Esquimalt Graving Dock, Esquimalt, BC
East End Dock Extension and Section 3 Dock Floor and Wall Refurbishment
Solicitation No: EZ108-211059/A
Addendum - 5

Addendum 5: The following changes/clarifications in the tender documents are effective immediately. This addendum will form part of the contract documents.

# ESQUIMALT GRAVING DOCK - EAST END EXTENSION AND SECTION 3 DOCK FLOOR AND WALL REFURBISHMENT

JOB NAME:	ESQUIMALT GRAVING DOCK - NORTH	EQUIPMENT DESIGNATION:	2NS-SP-1
JOB LOCATION:	MISSISSAUGA ON	EQUIPMENT TYPE:	NQ ( Circuit Breaker Type) PANEL 2 OF 2
DRAWN BY:	CAD	DRAWING TYPE:	ONE LINE DIAGRAM
ENGR:			SQUARE
DATE.	January 05, 2018	1

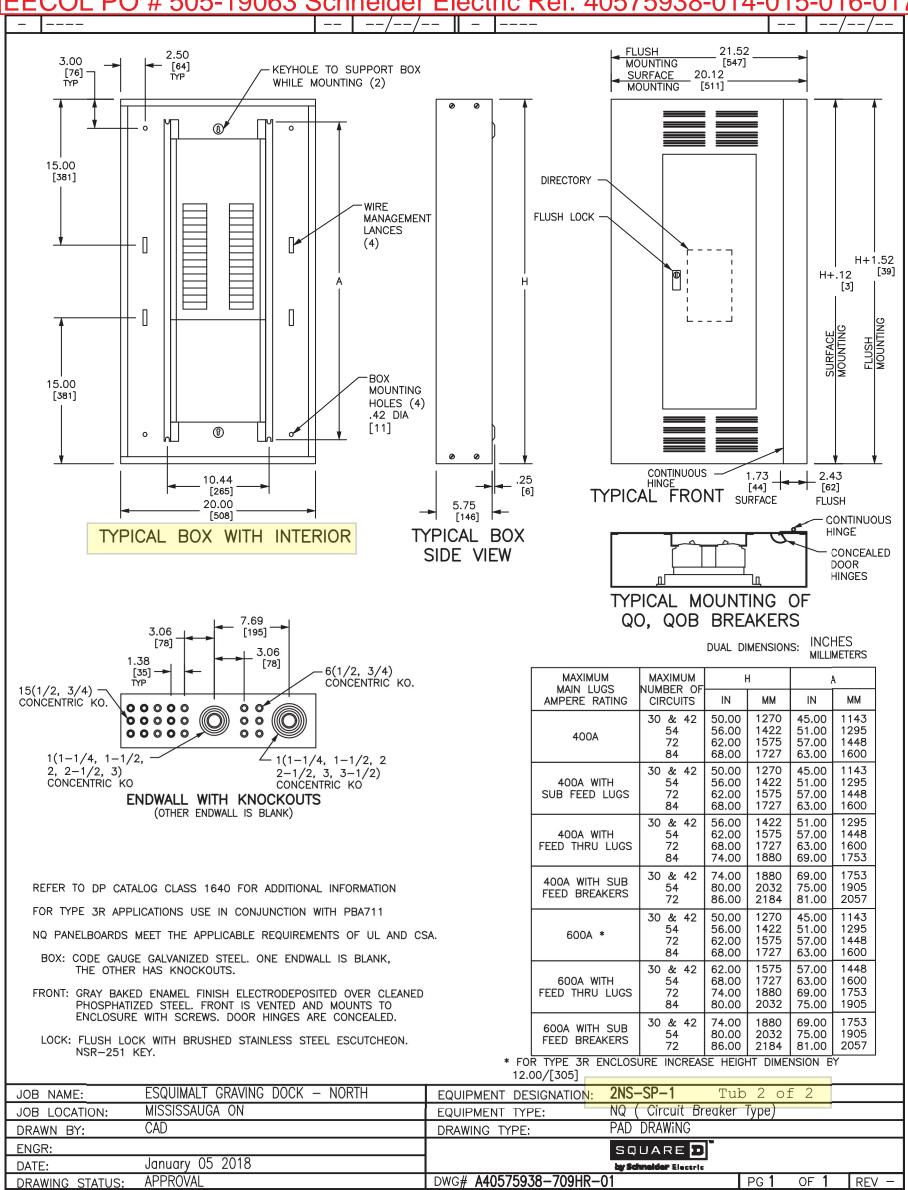
- Water 200mm nominal inside diameter
- Compressed air 150mm nominal inside diameter
- Sanitary 200mm nominal inside diameter
- Where pipes branch off to hydrants, pipe size shall be nominal inside diameter of 150mm.
- 10. Revise Drawings C02 and C03:
  - 150 HDPE Sanitary line to be 200 diameter sanitary line to match drawing M201.
  - 100 HDPE Compressed air line to be 150 diameter to match M201.
- 11. Revise drawing E400 Keynote #19 to read 2SSSR-SP-1.

- f) Panel Schedules have been added to the appendices as part of this addendum. Keynote #19 on page E400 should read 2SSSR-SP-1 not 2NS-SP-1.
- g) Pump motor control panles are in the scope of the project to supply.

**S212**

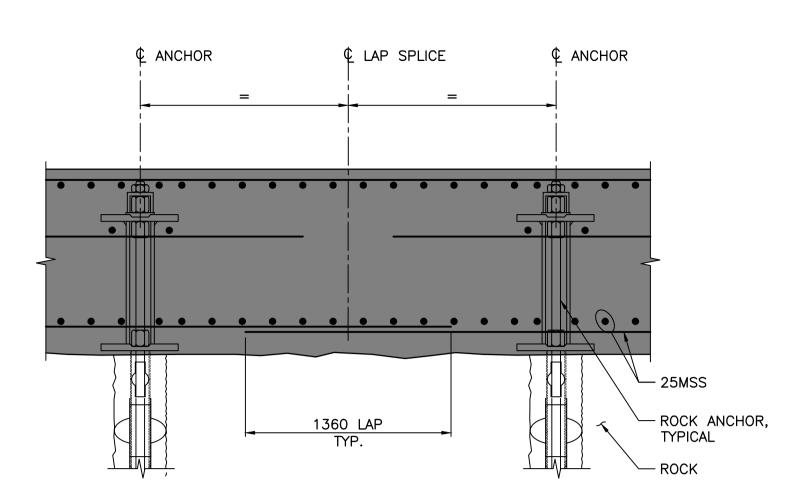
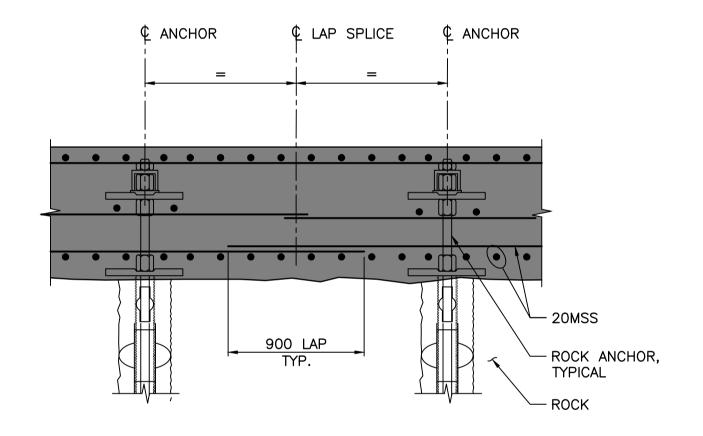
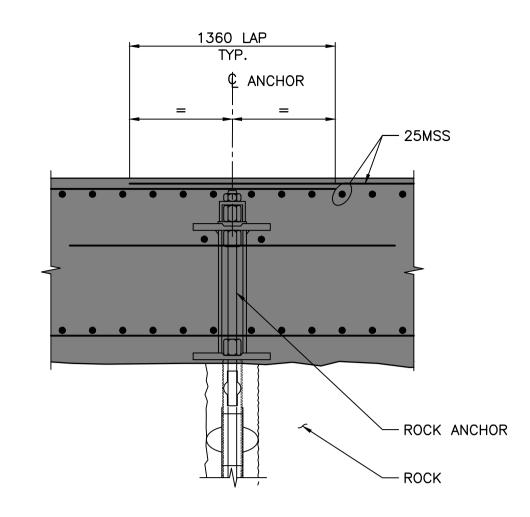
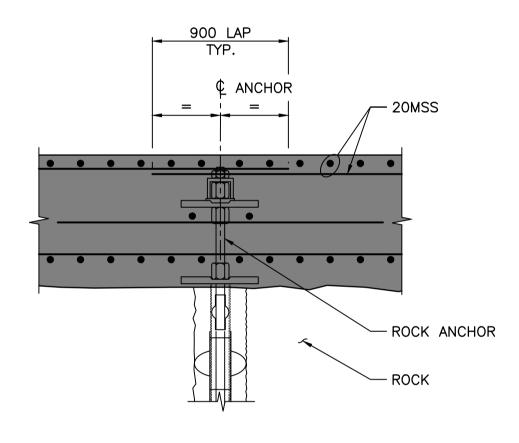
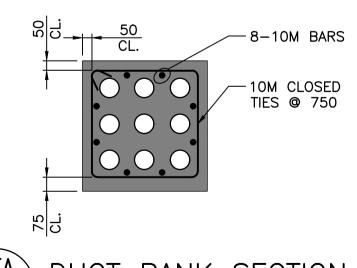
Drawing List, Add S212 - Concrete Reinforcement - Sheet 6

- 1. Revise Cover Sheet per attached clouded revisions
- 2. Revise drawing S204 per attached clouded revisions
- 3. Revise drawing \$206 per attached clouded revisions
- 4. Revise drawing \$207 per attached clouded revisions
- 5. Revise drawing \$208 per attached clouded revisions
- 6. Revise drawing \$209 per attached clouded revisions
- 7. Revise drawing S210 per attached clouded revisions
- 8. Add drawing S212 per attached
- 9. Clarifications Drawing M201:
